UNITED STATES PATENT AND TRADEMARK OFFICE

Office Action Summary	Application No. 10/567,960	Applicant(s) BAUER ET AL.	
	Examiner LAKIYA ROGERS	Art Unit 3744

DETAILED ACTION

This Office Action is in response to the amendment filed 12/28/2008. Claims 12-22 remain pending and claims 12,14,18,19 and 22 have been amended.

Fig. 1

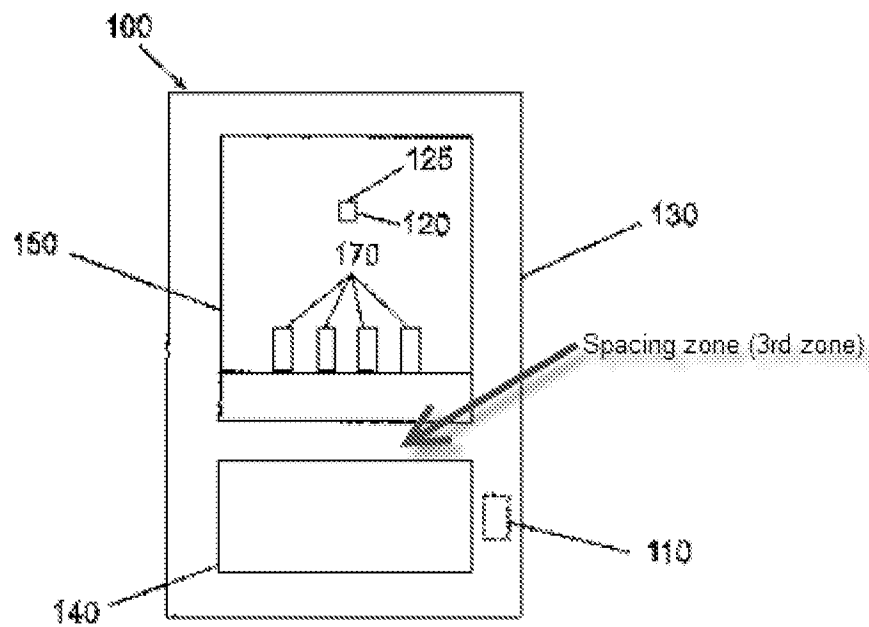
Regarding claim 12, Simmons teaches a refrigerating appliance (100) comprising a heat-insulating housing (130; Page 6, lines 14-16) and a cooling circuit including an evaporator (590), a compressor (560) and a condenser (570), a first assembly (150) including at least the housing and the evaporator; a second assembly (140) mounted remotely from the first assembly and separated therefrom by a spacing zone (see annotated figure below), said second assembly including at least the

Regarding claim 12, as currently presented does not recite the limitation of the refrigerating appliance being housed within kitchen furniture. Simmons teaches in Fig. 1 that the second assembly is mounted remotely from the first assembly and a coupling assembly extending across the spacing zone between the first and second assembly as recited and shown above in annotated Fig. 1. For the purpose of this examination, examiner presumes the word remotely to mean *situated at some distance away*.

Simmons ('350) teaches in Fig. 1 the technique of separating the first and second zone by a third zone with the third zone being devoid of the of the first and second assemblies as recited and illustrated above in annotated Fig. 1.

Fig. 2

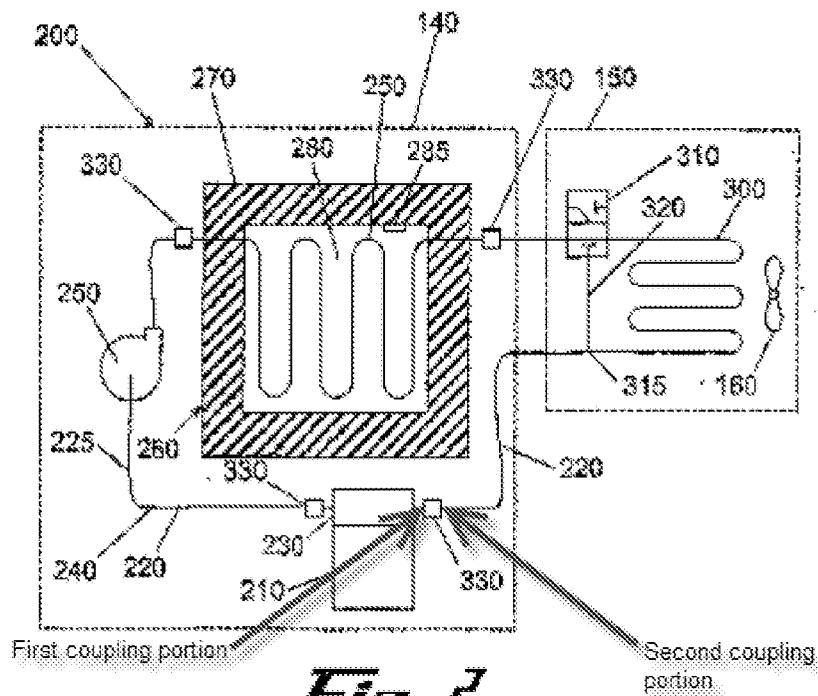
compressor (Page 6, line 34 – Page 7, line 3); and a coupling assembly (all couplings 330 shown in Fig. 2) extending across the spacing zone between the first and second assembly for movement of refrigerant therethrough (Page 8, lines 9-10 and lines 33-34).

Regarding claim 13, Simmons teaches the invention as recited above and further teaches in Fig. 2 including a coupling (330) disposed in a coolant pipe (220) connecting the first assembly and the second assembly (Page 8, lines 9-10 and lines 33-34).

Regarding claim 14, Simmons teaches the invention as recited above and further teaches in Fig. 2 (see annotated Figure 2 below) the refrigerating appliance wherein the coupling (330) including a first coupling portion capable of being attached to the first assembly (150) and a second coupling portion attached to the second assembly (140), the two coupling portions are self-closing in the uncoupled state allowing the first assembly and the second assembly to be detachably separable from one another (Page 8, line 33-Page 9, line 5) for remote mounting of said first assembly and said second assembly separated by said spacing zone.

Regarding claim 16, Simmons teaches the invention as recited above and further teaches in Fig. 2 the refrigerating appliance including the condenser (570

included in the cold producing unit 210) being part of the second assembly (140) (Page 12, lines 28-29).
